Project	IEEE 802.16 Broadband Wireless Access Working Group < http://ieee802.org/16 >	
Title	Entering the community using coexistence proxy	
Date Submitted	2006-02-28	
Source(s)	Phillip Barber, Wu Xuyong, Pan Zhong, Zhao Quanbo, Huawei Huawei Industrial Base, Bantian, Longgang, Shenzhen 518129 P.R.C	Voice: +86-755-28780808 PBarber@BroadBandMobileTech.com wuxuyong@huawei.com
Re:	80216h-06_005: Call for Comments and Contributions: IEEE 802.16 License-Exempt Task Group (2006-02-06)	
Abstract	Broadcasting the IP address of BS is putting the BS into risk of being attacked from the internet, to use coexistence proxy between BSs in coexistence negotiation and cooperation could be a way out.	
Purpose	To consider a acceptable way of delivery the contact information between BSs in a community.	
Notice	This document has been prepared to assist IEEE 802.16. It is offered as a basis for discussion and is not binding on the contributing individual(s) or organization(s). The material in this document is subject to change in form and content after further study. The contributor(s) reserve(s) the right to add, amend or withdraw material contained herein.

Entering the community using coexistence pr

Figure hxx. IBS entering the community by neighbor update request broadcasting

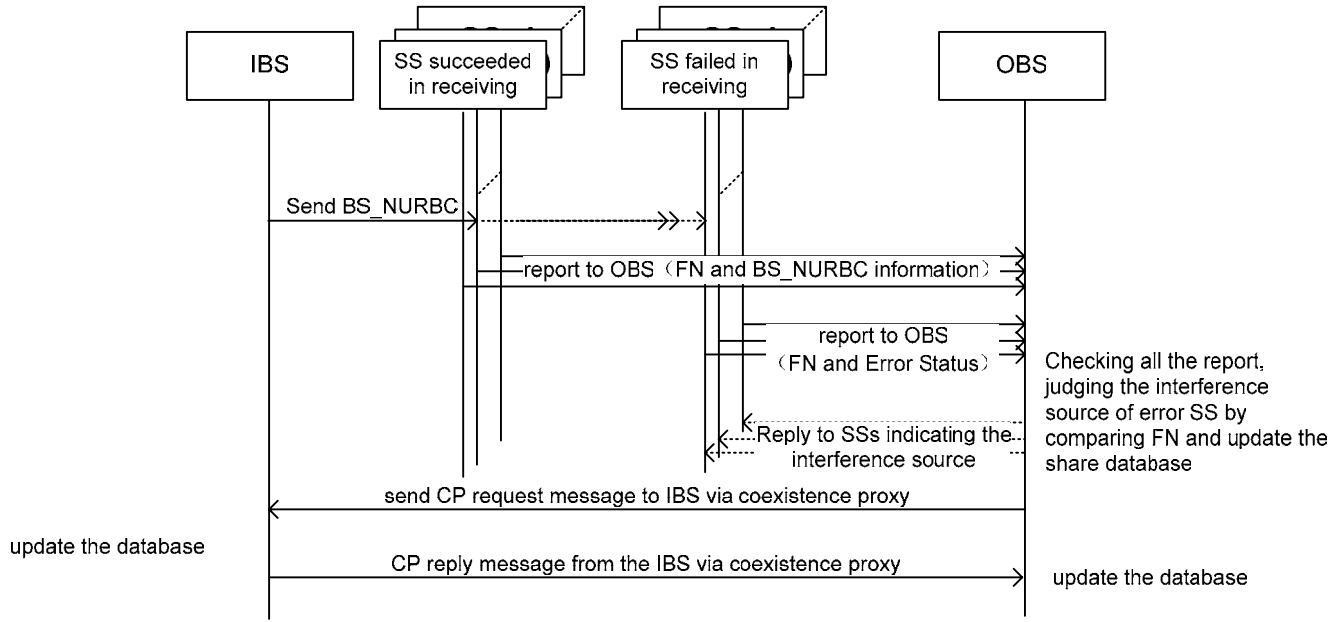
The BS_NURBC (see 15.6.6.2.1) broadcasting procedure is unidirectional, only from the BS to the SSs in common coverage of the BS and its neighbors', and the SSs shall report all the useful information to their OBSs they associated to. The SSs that succeed in receiving the message should report the content of BS_NURBC and the frame number of the starting frame of BS_NURBC, the SSs which failed to received the broadcasting message but got get BS_NURBC like as interference in the CTS should report the error status and the starting frame number of receiving the interference in CTS. IBS use ICTS to broadcast BS_NURBC message, the content in the message will enable its neighbor systems to communicate with the IBS in the IP network to coordinate by coexistence protocol. By the IP address of IBS's coexistence proxy and the BSID reported from the SSs with RTK, the OBSs will then communicate with the IBS in the IP network via their coexistence proxy, and go further coordinate using IP network. And by checking the frame number in the report, OBS need to find out if the SSs that report the error status in BS_NURBC receiving have got the same interference source, then OBS will update the database and reply to the SSs which have send the error report.(see figure hxx.)

Figure 18 — System Architecture

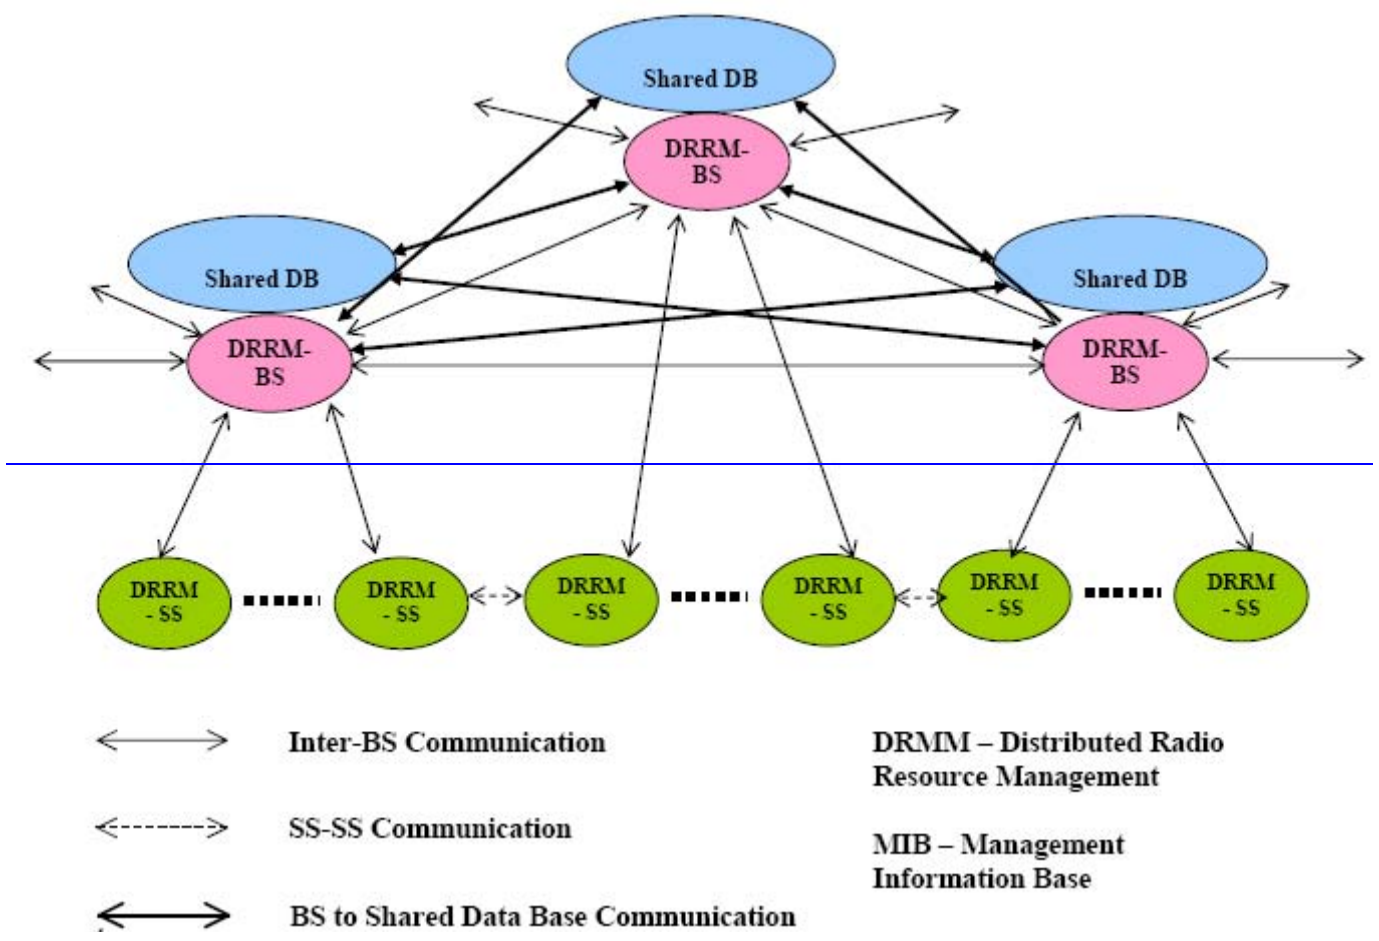
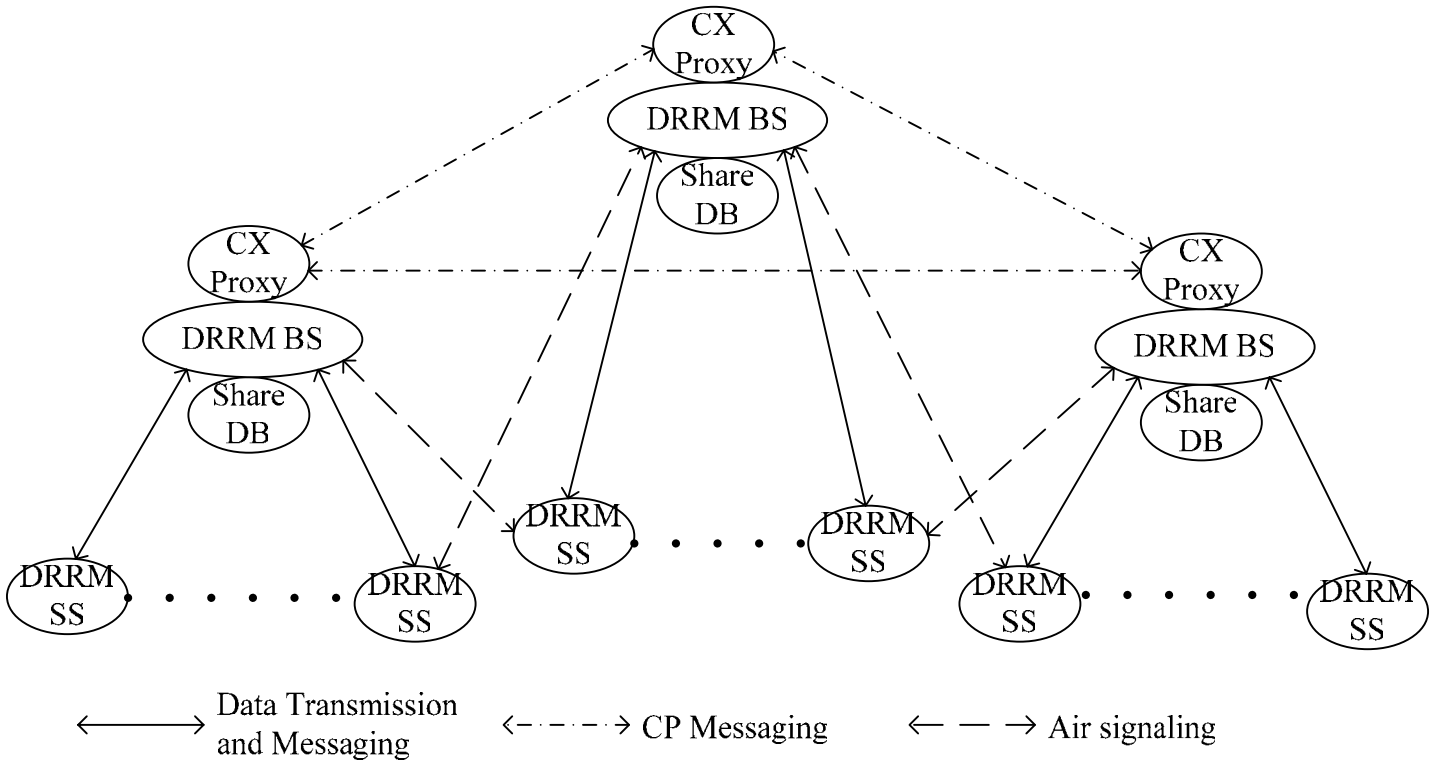
The architecture for Radio Resource Management in the context of IEEE 802.16h it is a distributed one and allows communication and exchange of parameters between different network systems. A network system consists from a Base Station base station and its associated Subscriber-subscriber Stationsstations and its coexistence proxy.

A subscriber Sstation may include an instance of DRRM, adapted to SS functionality in 802.16h context. The following figure shows the functional diagram of the IEEE 802.16h network architecture:

Figure h19 —Network architecture

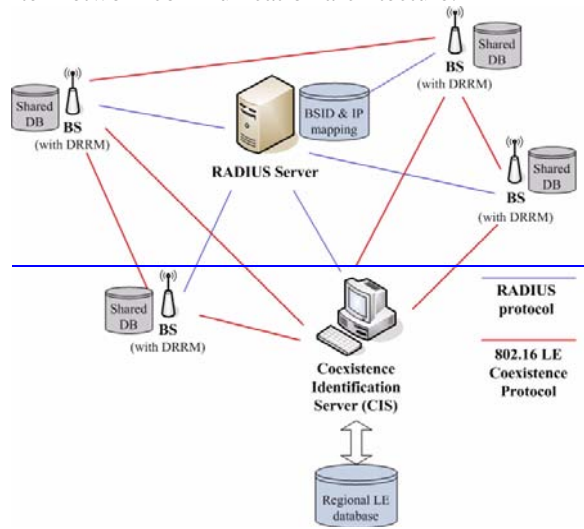
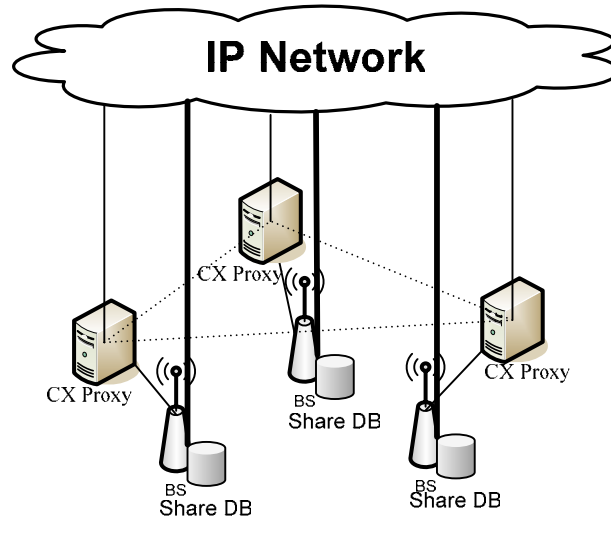
- The coexistence proxy of every base station maintains the mapping of the IP address and the BSID of their serving BSs. All the CP messages between the different systems should be sent and received via their coexistence proxies instead of directly between the base stations. So the IP address will not be known outside the system. The coexistence proxy will forward the CP messages for the base station.
